ADDENDUM NO. 1

Date: September 26, 2024
 Project: **Rafael Meadows Pump Station Fencing Improvements**
 Job No.: 22300-01

FENCE AND GATE DETAILS
(TYPE A - BLACK VINYL COATED)

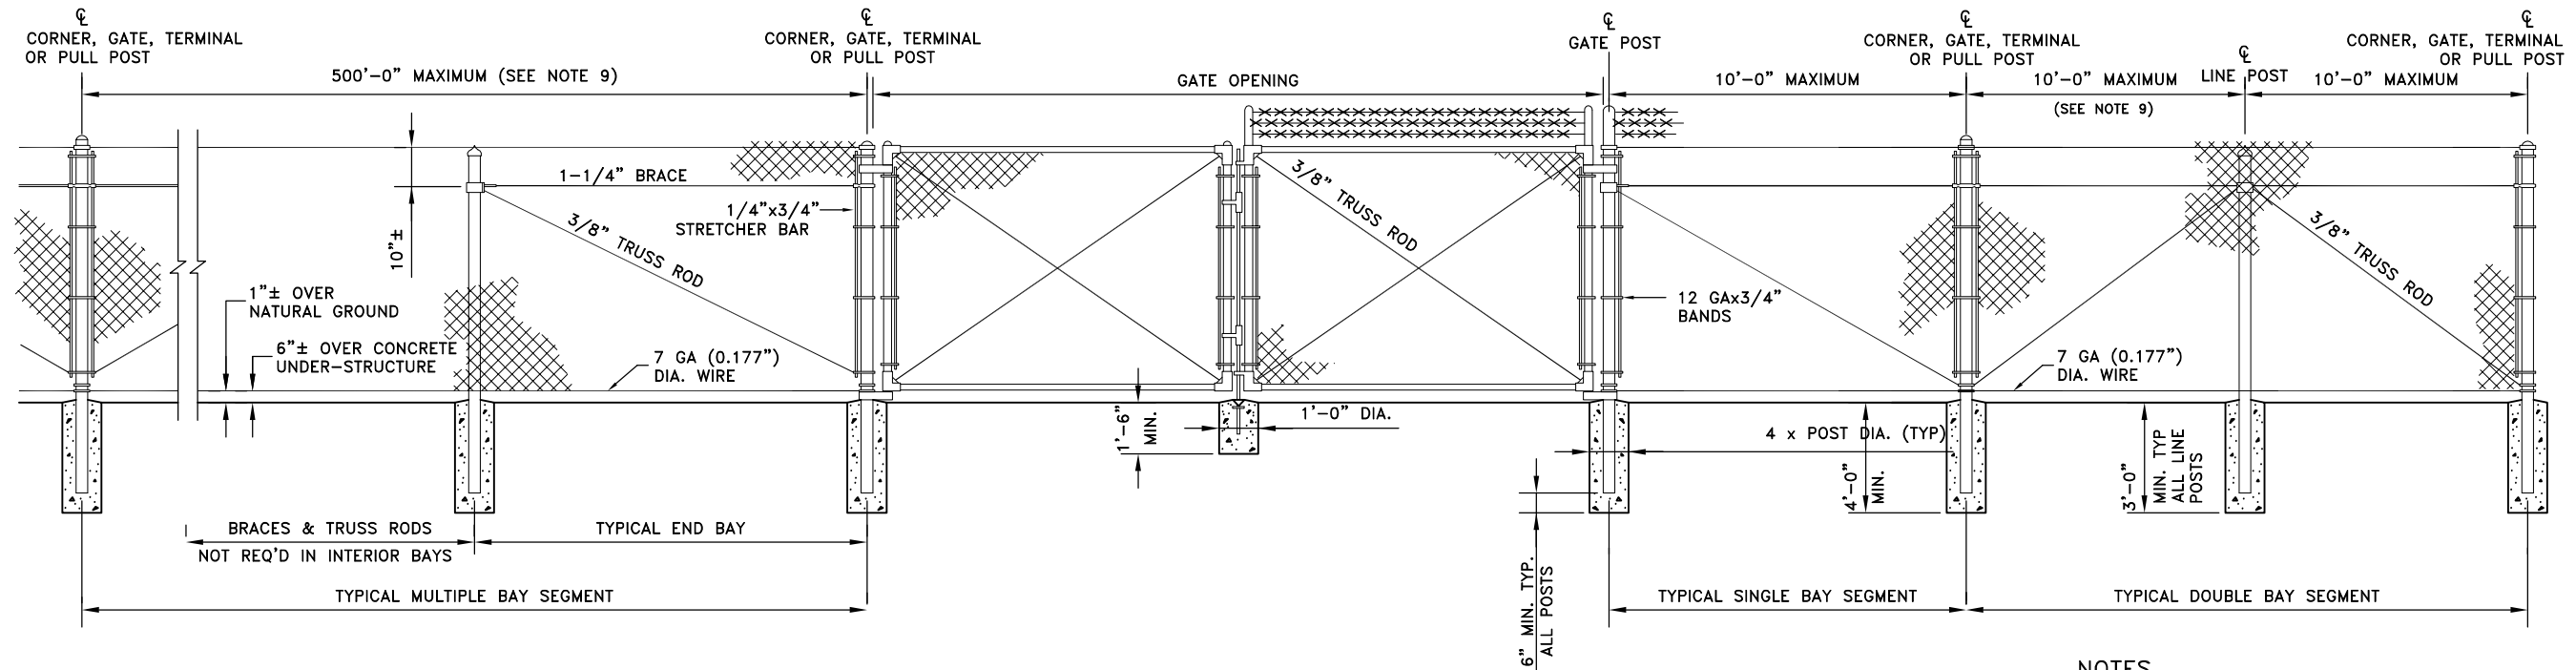
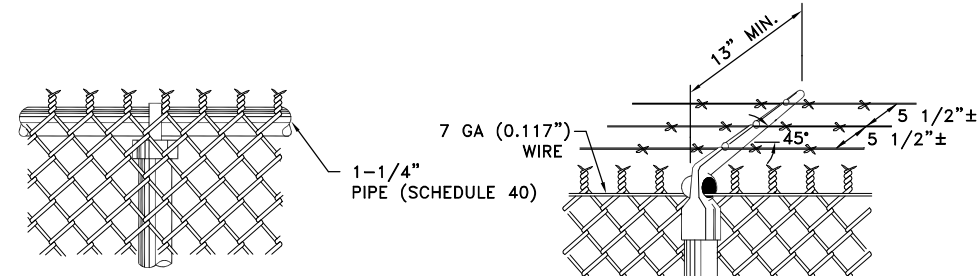
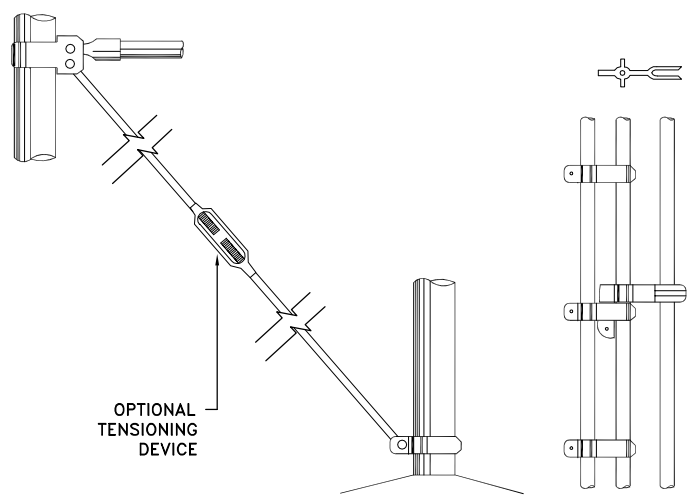
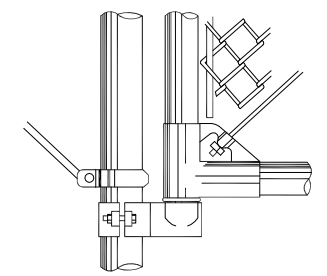
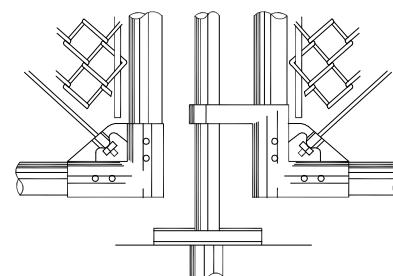
Q5. Does the black vinyl coated chain link requires barbwire on top? Page 132 calls out for both fence with barbwire and fence with no barbwire.

Q7. The details on page 132 of 133 show the chain link fence without barb wire. However there is a small detail showing barb wire and the existing chain link fence at the site does have barb wire. Please clarify, if the fence gets barb wire.

Response: The black vinyl coated chain link fencing requires black vinyl coated barbed wire on top (see Q1 and Q2 above).

Response: The black vinyl coated chain link fencing requires black vinyl coated barbed wire on top (see Q1 and Q2 above).

TWISTED AND BARBED SELVAGE
(TYPE II FENCE)

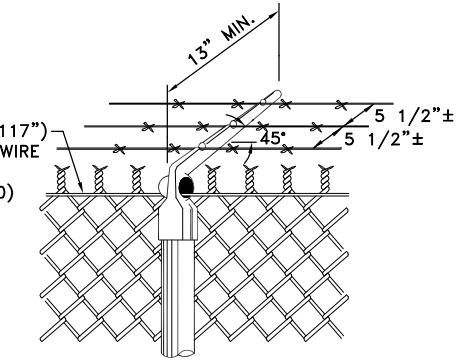
Q1. Should we ignore the reference to the 1-1/4” sch. 40 pipe top rail shown on the “TWISTED AND BARBED SELVAGE” detail shown on sheet 2? There are other/multiple references throughout that same sheet that would indicate a tension wire is to be installed at the top of this fence (in-lieu of a pipe rail) so I’d just like to confirm.

Response: The specified Type A - Black Vinyl Coated Fencing with 3-Wire Black Vinyl Coated Barbed Wire has a nominal height of 7’. Per note # (4) on Sheet 2 of the Drawings, contractor shall use Twisted and Barbed Selvage (Type II Fence) for the project, which requires a 1-1/4” Schedule 40 pipe as top rail of the fencing.
